Project Title: EAST CENTURY GATEWAY PLAZA	Building Permit #:	City Drainage #: K20-D061
DRB#: EPC#:		Work Order#:
Legal Description: LOTS 1-3 EAST CENTURY GATEWAY PLAZA		
City Address: 10201 CENTRAL NE		
		Contact: DAVID SOULE
Engineering Firm: RIO GRANDE ENGINEERING		
Address: PO BOX 93924, ALBUQUERQUE, NM 87199 Phone#: 505.321.9099 Fax#: 505.8	72.0999	E-mail: DAVID@RIOGRANDEENGINEERING.COM
Phone#: 505.321.9099 Fax#: 505.8		
Owner: TEKIN PROPERTIES		Contact:
Address: 8036 OAK POINT DRIVE, FRISCO, TEXAS 75034		,,,,,,,,,,,,,,,,,,,,,,,,,,,,,,,,,,,,,,
Phone#: Fax#:		E-mail:
Architect: PETER BUTTERFIELD		Contact: PETER BUTTERFIELD
Address: Phone#: Fax#:		E-mail:
Phone#:		
Surveyor: SURV-TEK	<u> </u>	Contact: rUSTY hUGG
Address:		
Phone#: 9 Fax#:	,	E-mail:
Contractor:		Contact:
Address:		
Phone#:		E-mail:
	CHECK TVPE OF APPROV	VAL/ACCEPTANCE SOUGHT:
TYPE OF SUBMITTAL:	SIA/FINANCIAL GUARAN	
DRAINAGE REPORT	PRELIMINARY PLAT API

RE: East Century Gateway Plaza
Grading and Drainage Plan
Engineers Stamp Date 6/11/14 (K20-D061)

RE: Drainage Resubmittal

Re: Tracts 1 & 3 East Central Gateway Plaza, 10201 Central Avenue NE, Traffic Circulation Layout

Attachments: Freddy-TCL COMMENTS -sheet (3).pdf

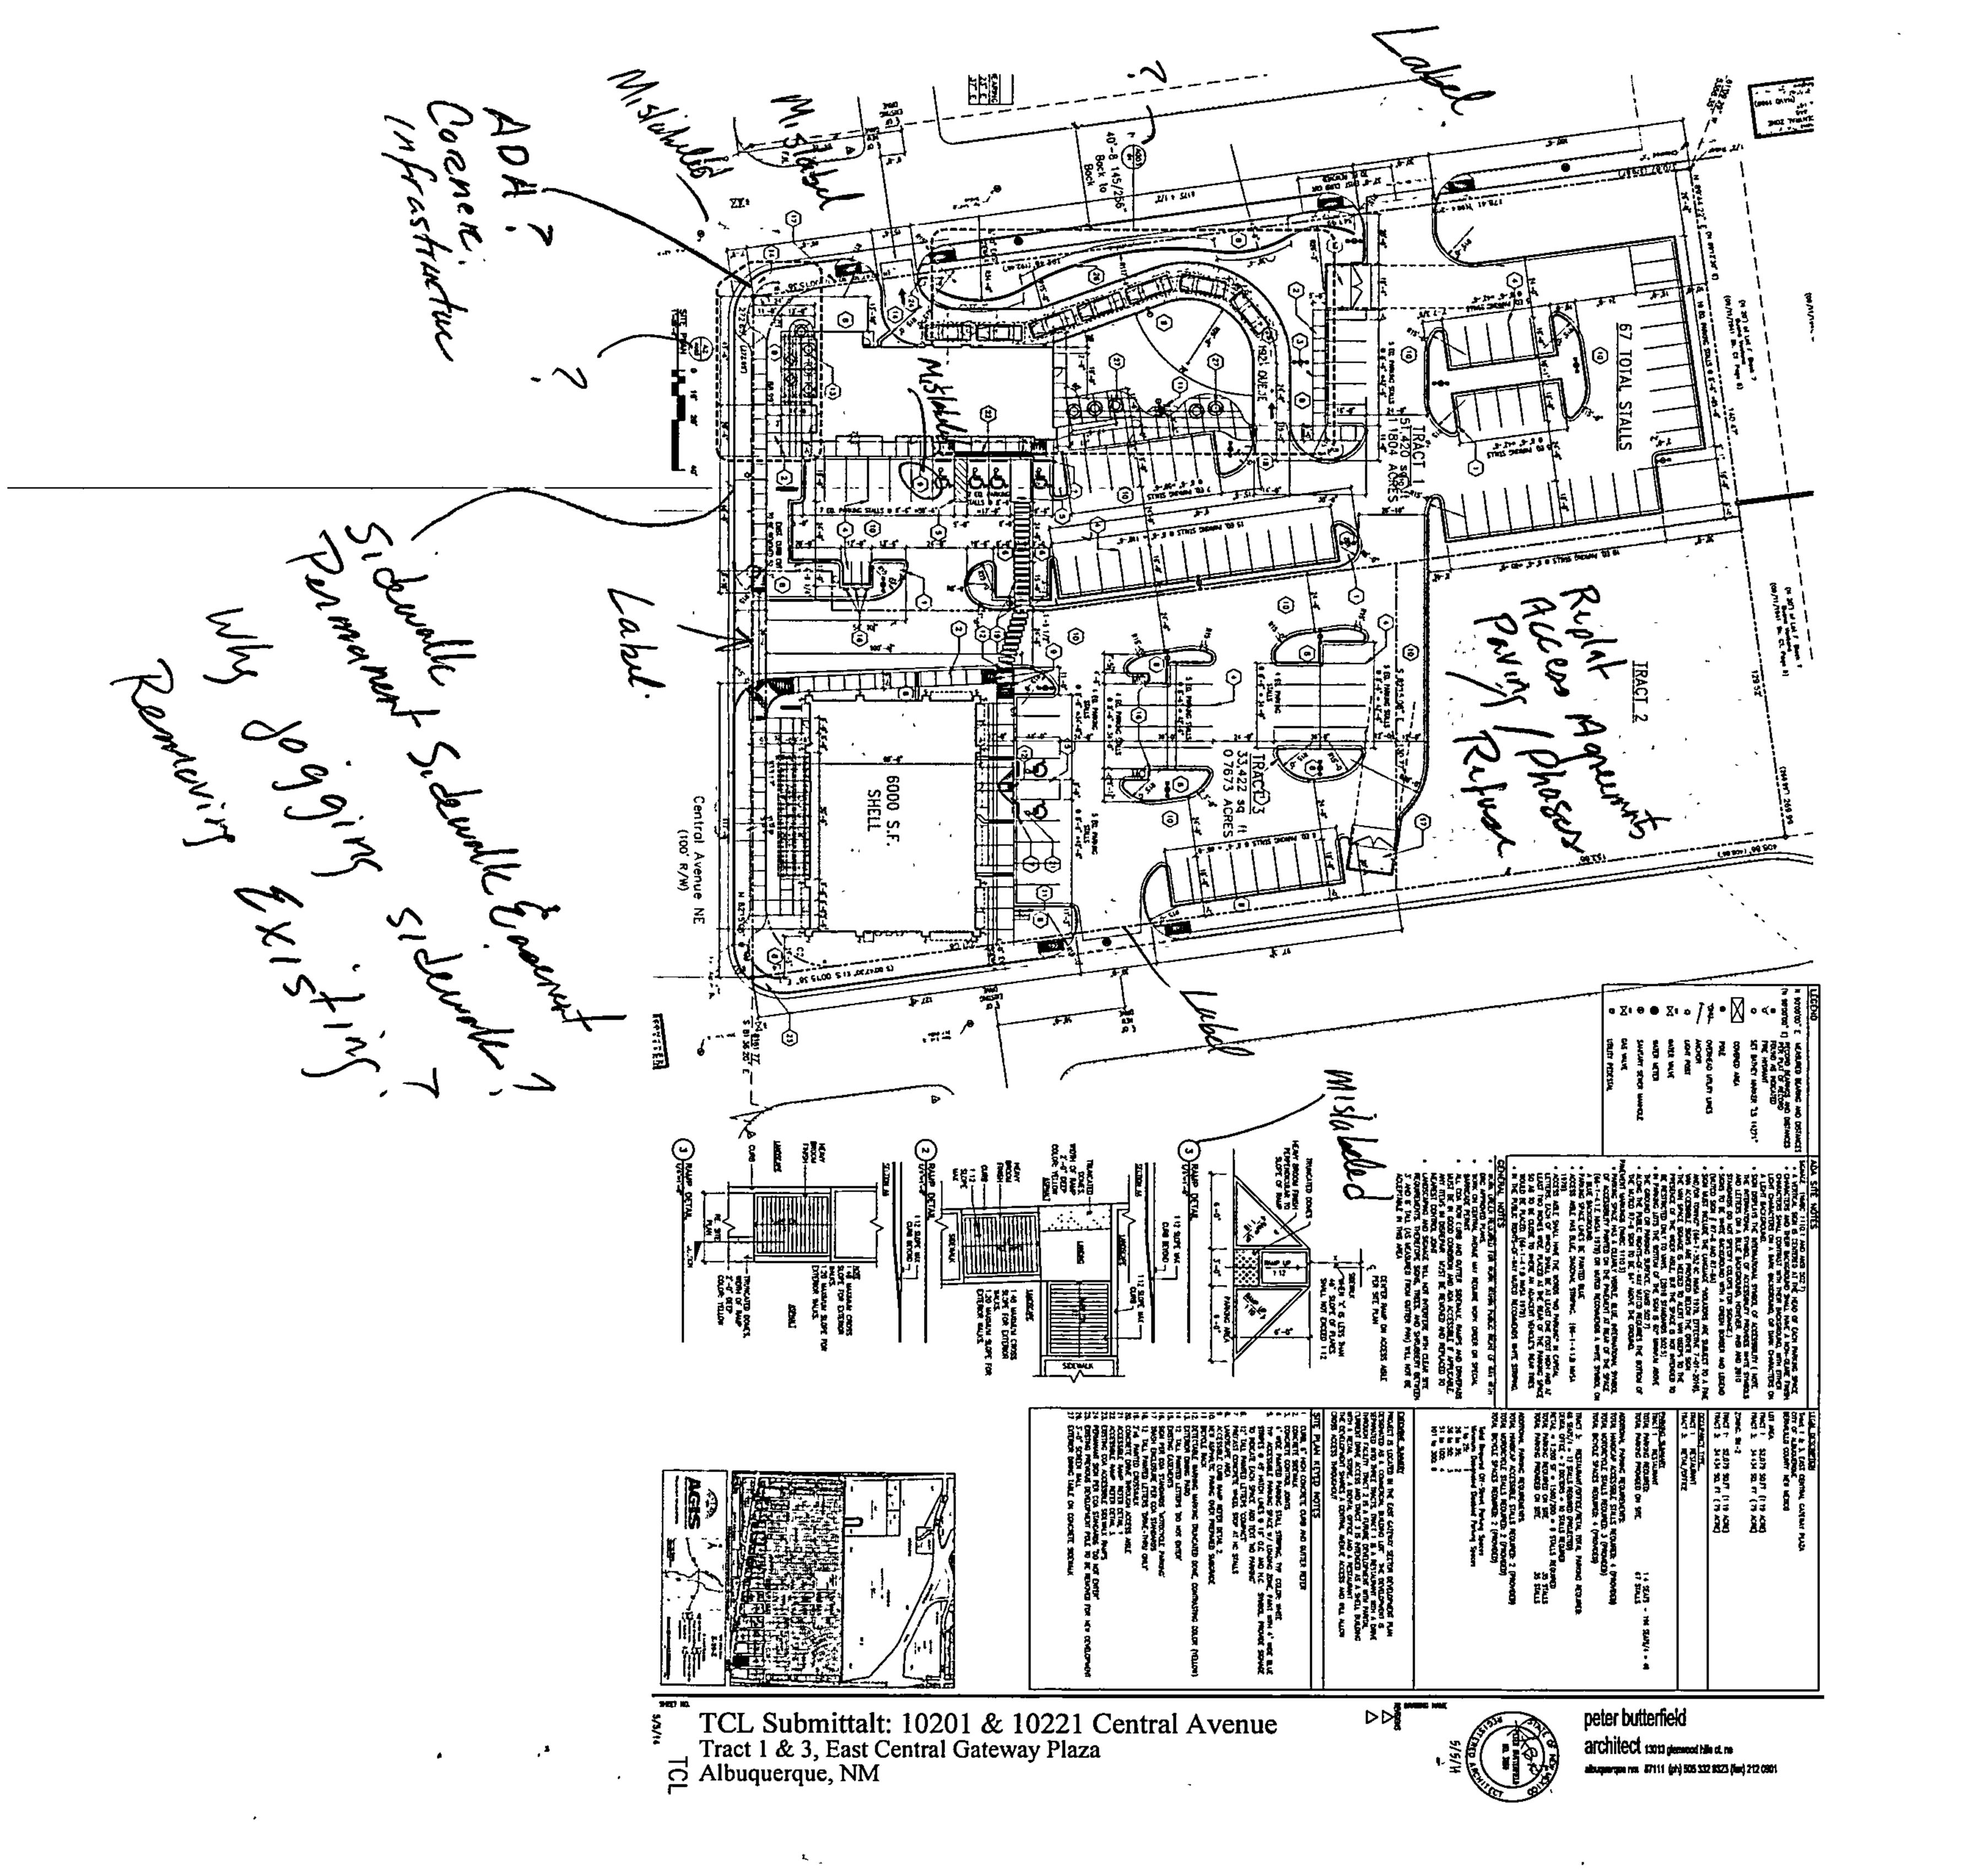
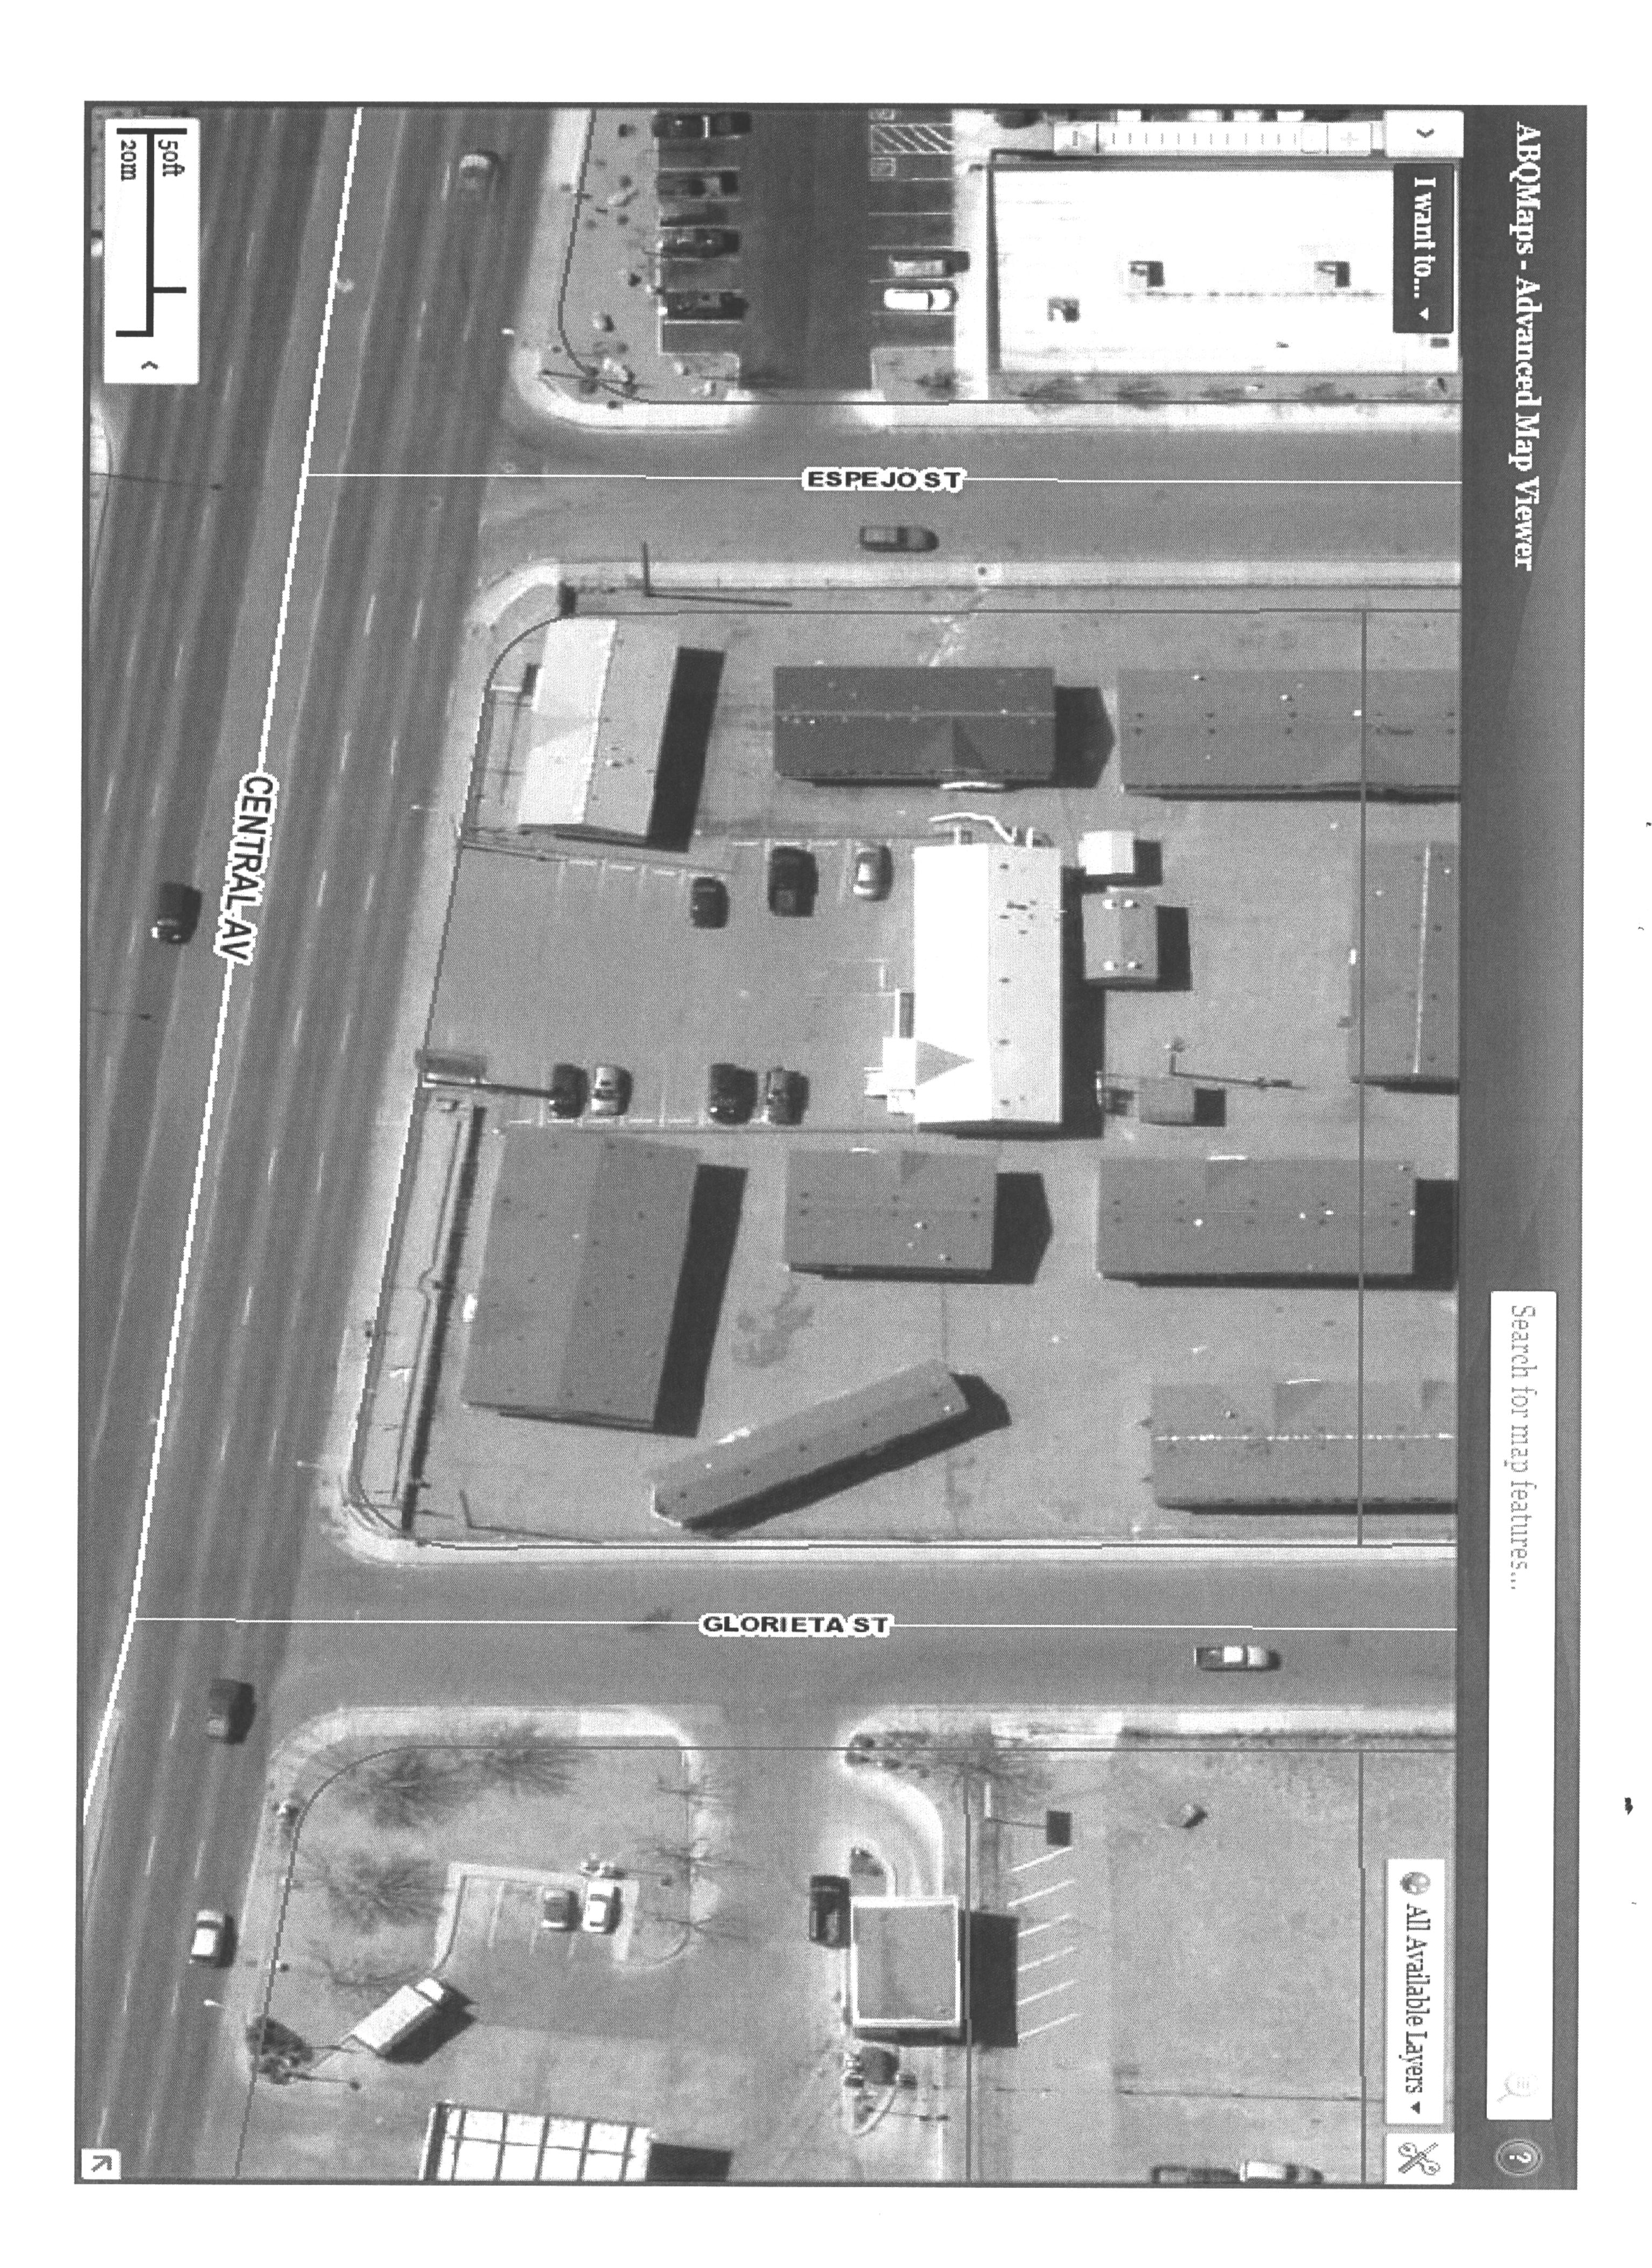
Please refer to attachment for comments. This was a cursory review and I may have missed necessary information.

I am not clear on what is happening along Central frontage with the sidewalk....what exists, what is being removed, what is proposed. Also, if the public sidewalk is located within the private property, a Permanent Sidewalk Easement must be provided. The forms can be accessed on-line or over-the-counter.

I have removed all references to the changes required on the comment letter. this is the sheet I would like to submit. If you can do a quick review and let me know if there are any concerns before I head back down there I would greatly appreciate it. thank you.
